Detailed response to Architectus' request for additional information (RFI 2 May 2021) DA/836/2020 Liverpool Civic Place

Proposed Mixed-Use Development Known as Liverpool Civic Place – 52 Scott Street, Liverpool

Liverpool Civic Place - DA RFI 2

6b Replacement ramp from Scott Street

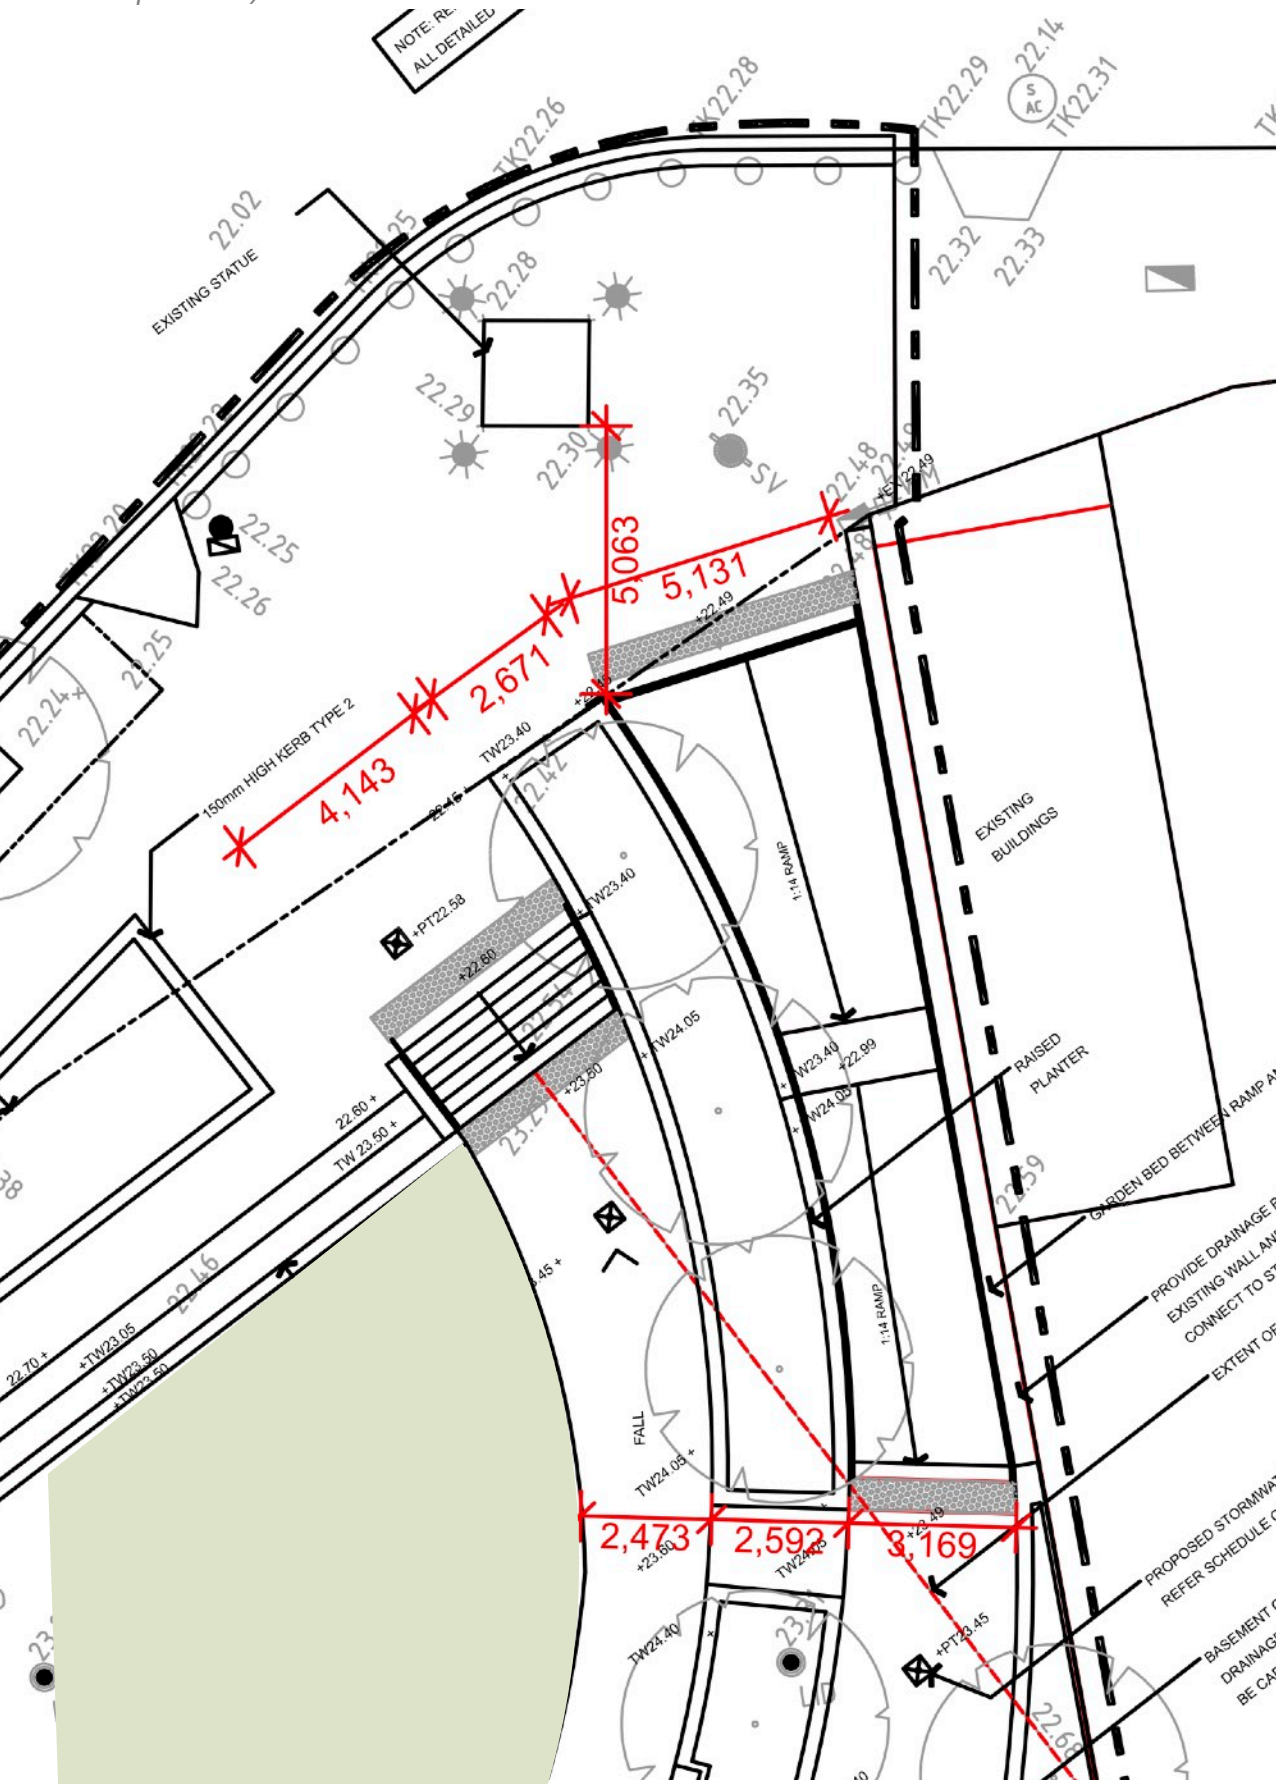
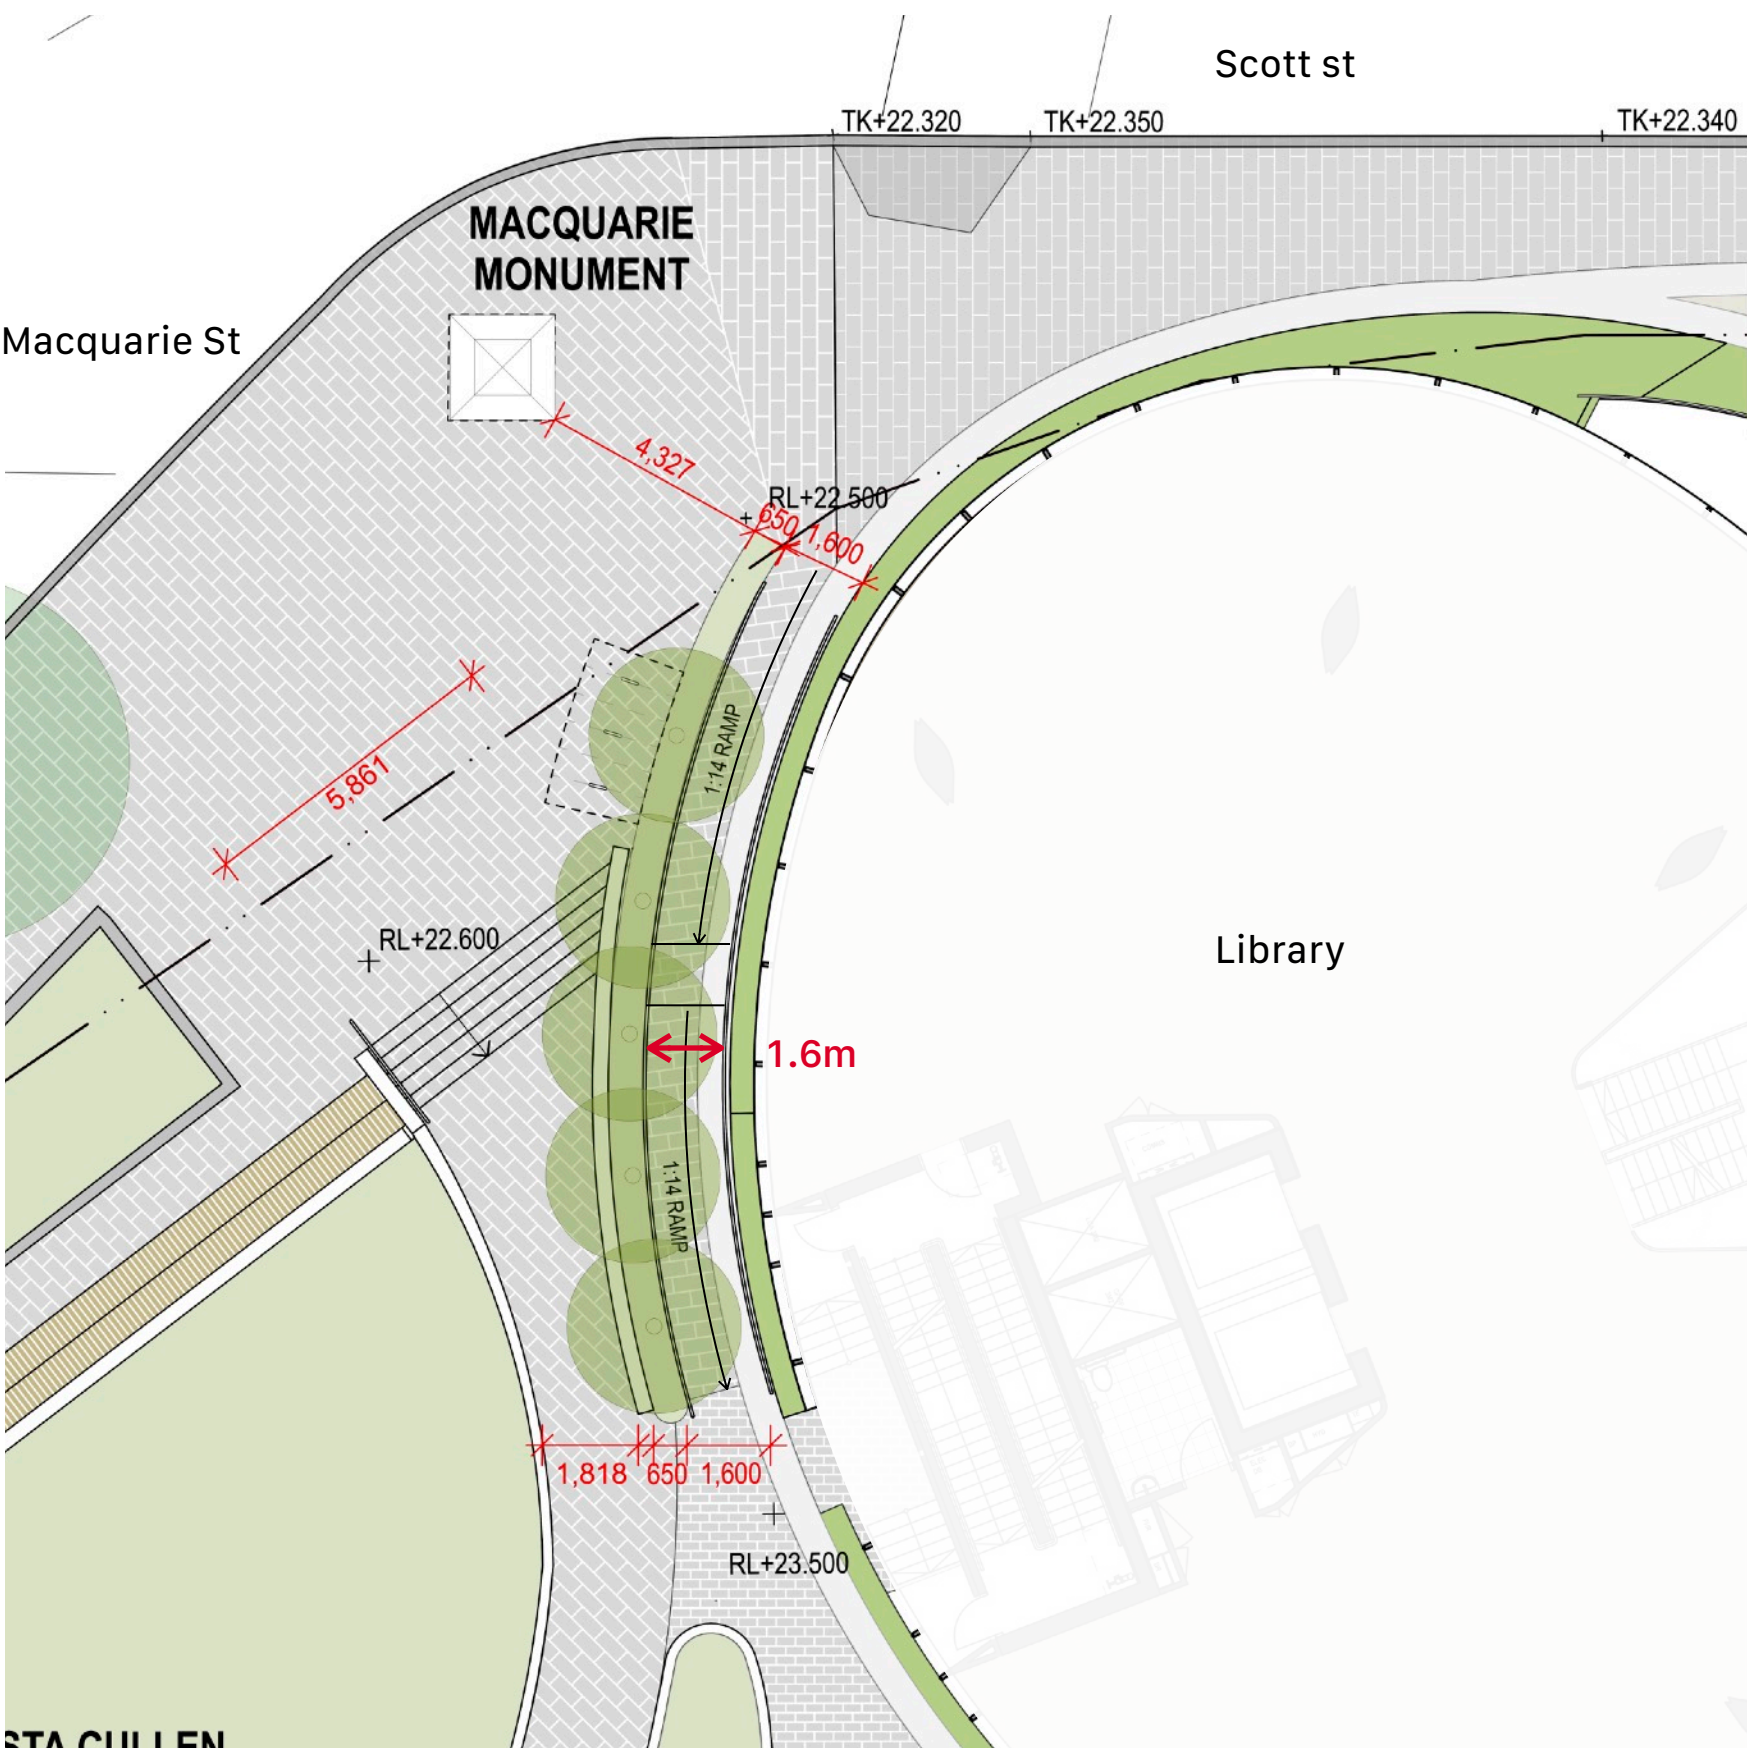
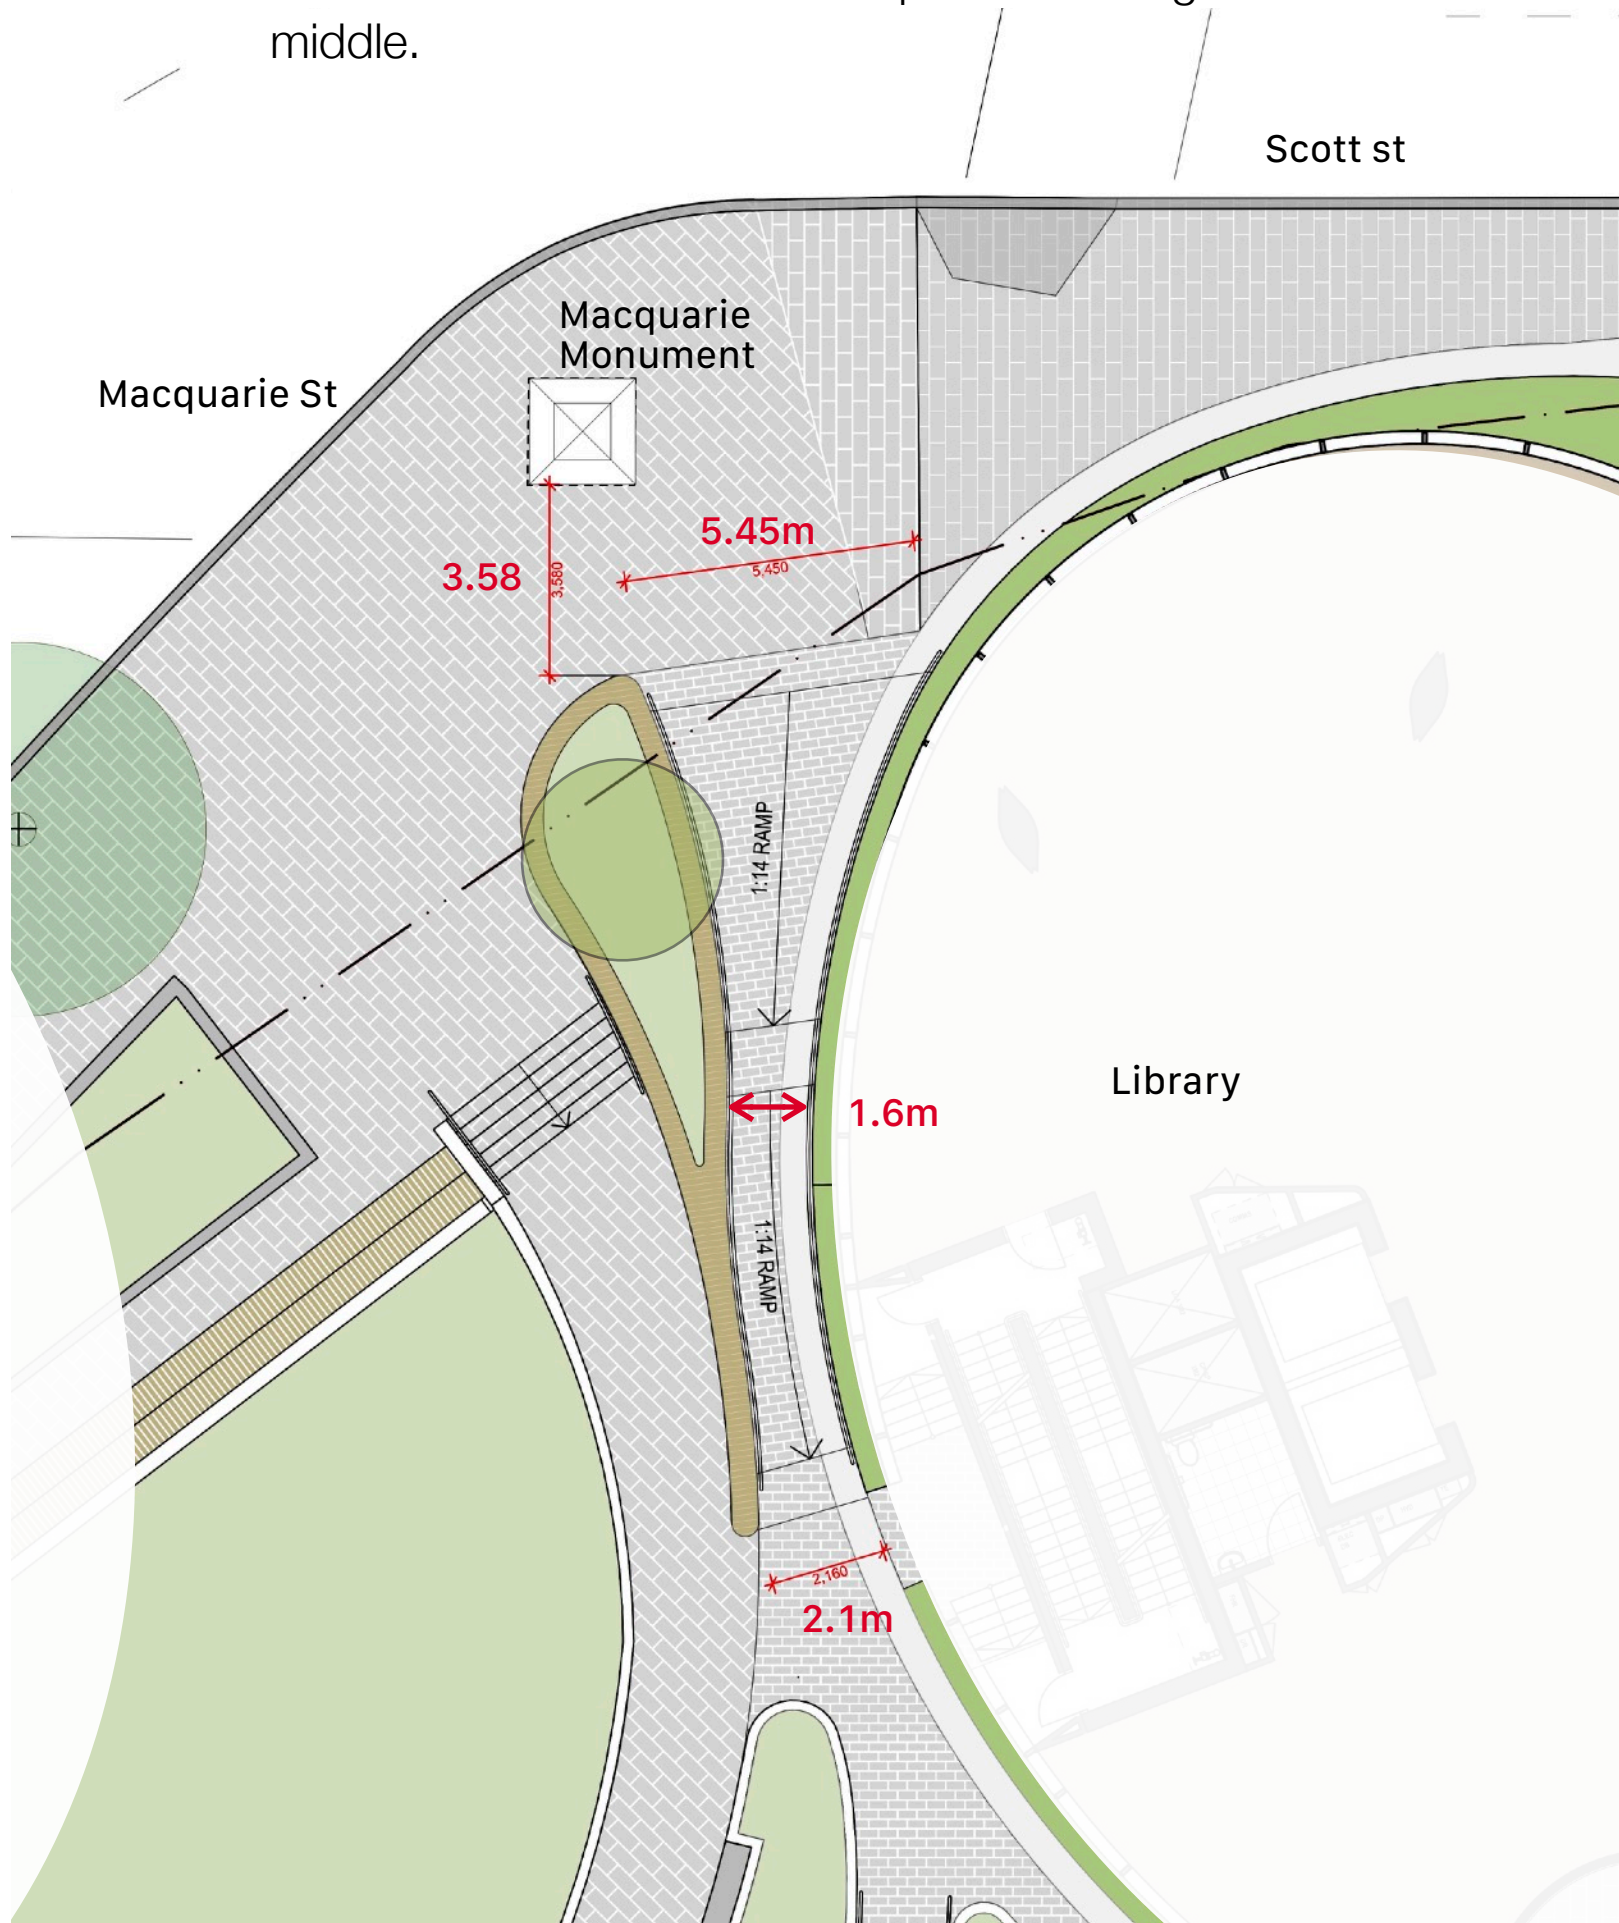
The library building proposes to encroach into this ramp. In response, a replacement ramp is proposed which retains access to the site from Macquarie Street and vice versa. However, the replacement ramp appears to be only 1.5m in width (although no dimension provided on the plans). The submission contends that a width of

2m should be provided. In this regard, it is considered suitable for a replacement ramp to be of a width that allows two wheelchairs to pass each other along the length of the ramp, as well as that part of the ramp that provides access to and from the subject site.

The ramp width from Scott street is to be increased from 1.6m to over 5m. This is a 3x width increase, presenting a more generous and welcoming ramp address to the intersection, and commensurate in width to the existing ramp condition. Similarly, the

ramp width to the south by Augusta Cullen Plaza has been increased from 1.6m to 2.1m.

To preserve width for the public stair and planter, we have maintained the 1.6m ramp width through the middle.
